From: Nelson, Tyson [tyson.nelson@ag.idaho.gov]
Sent: Thursday, June 27, 2013 11:19 AM
To: Clelland, Steve
Subject: IDL Claims in Basin 63
Attachments: 63-9457 Rec.pdf; 63-9462 Rec.pdf; 63-9479 Rec.pdf

I reviewed the recommendations for IDL's claims in the Spring 2013 Director's Report. Thanks for your good work. I have a few questions for three recommendations.

IDAHO DEPARTMENT OF WATER RESOURCES
RECOMMENDATION OF WATER RIGHTS ACQUIRED UNDER STATE LAW

RIGHT NUMBER: 63-9462
NAME AND ADDRESS: STATE OF IDAHO
DEPT OF LANDS
300 N 6TH ST STE 103
PO BOX 83720
BOISE ID 83720-0050

63-9462

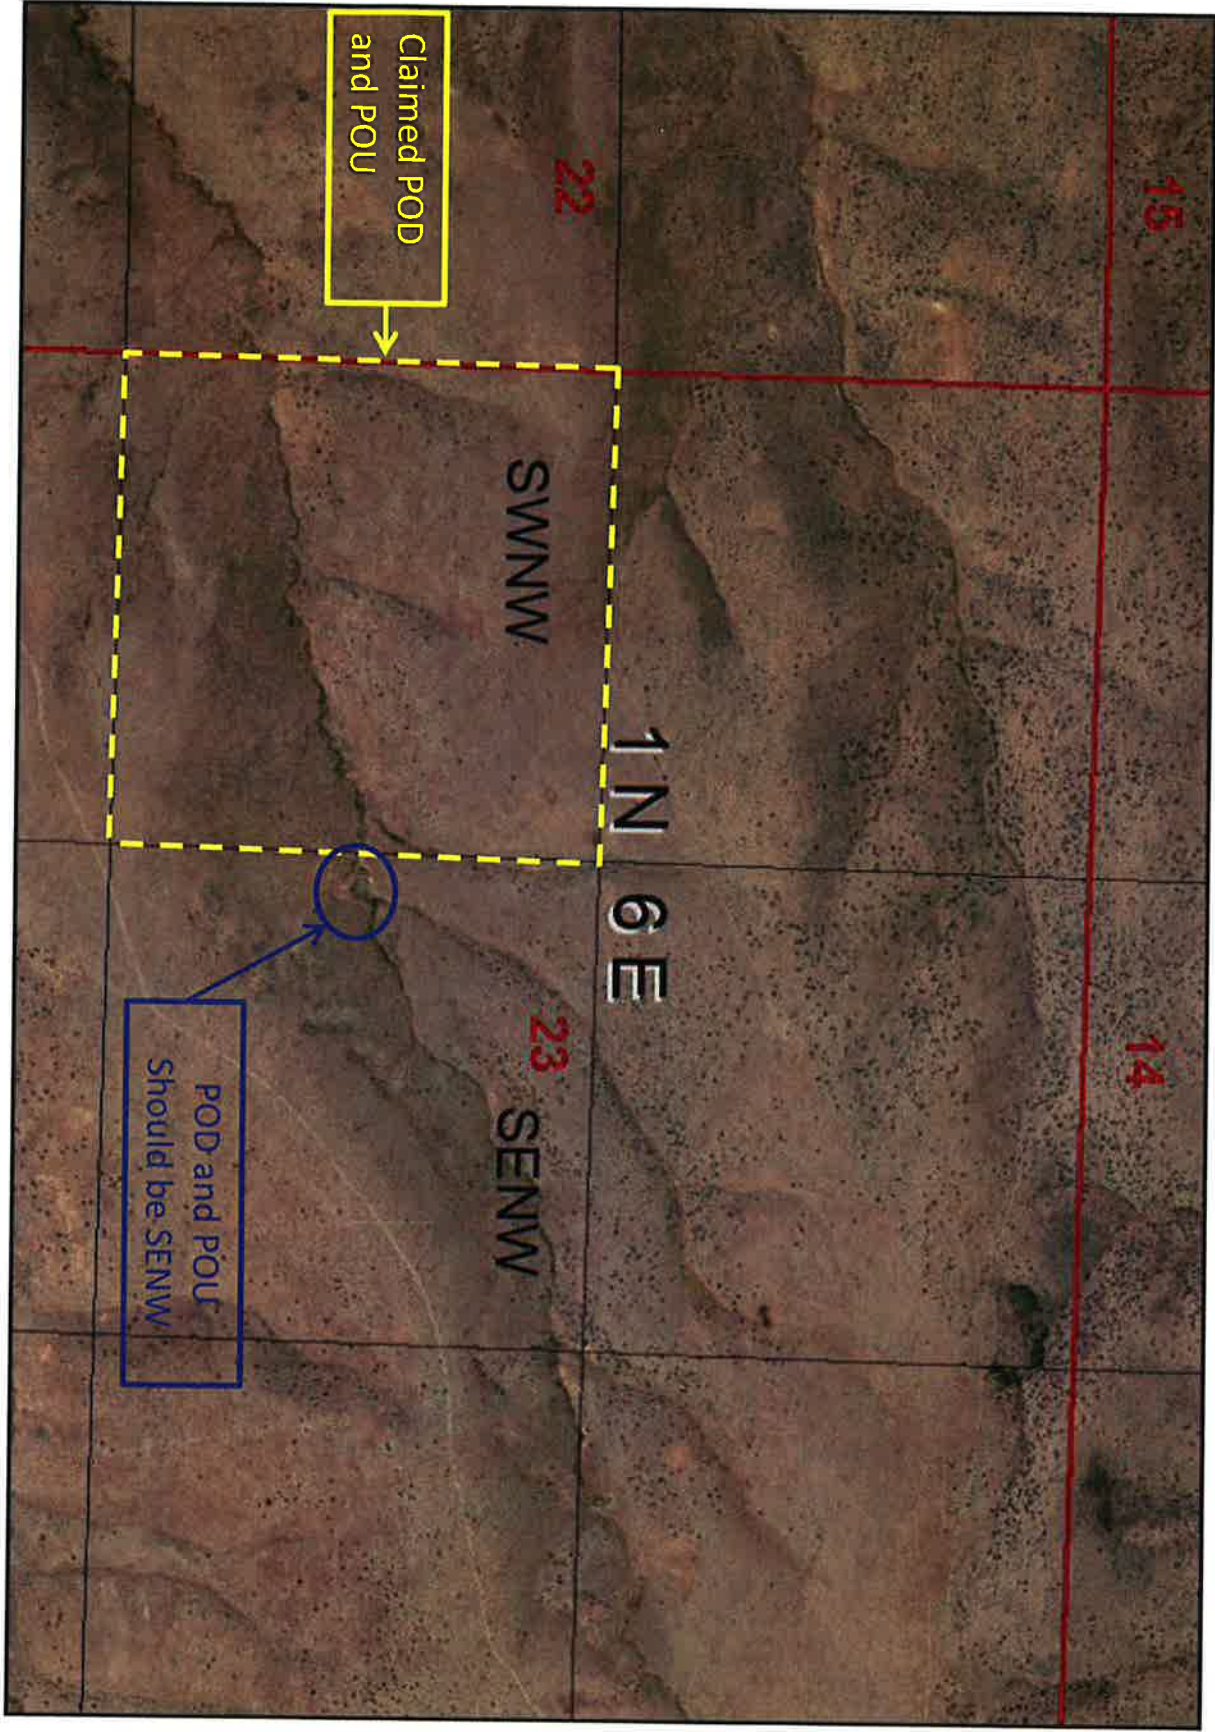
The application for permit describes this right as a pond developed from a spring. Aerial photography shows that the pond is located in SENE instead of SWNW.

POD as per Backfile

BLM id of pond for 63-9462

Pond estimated location per
Back file map & aerial views.

Pond found in S. 23 SE NW.

update pos/pos per GPS data from 1DL

Convert use to Storage
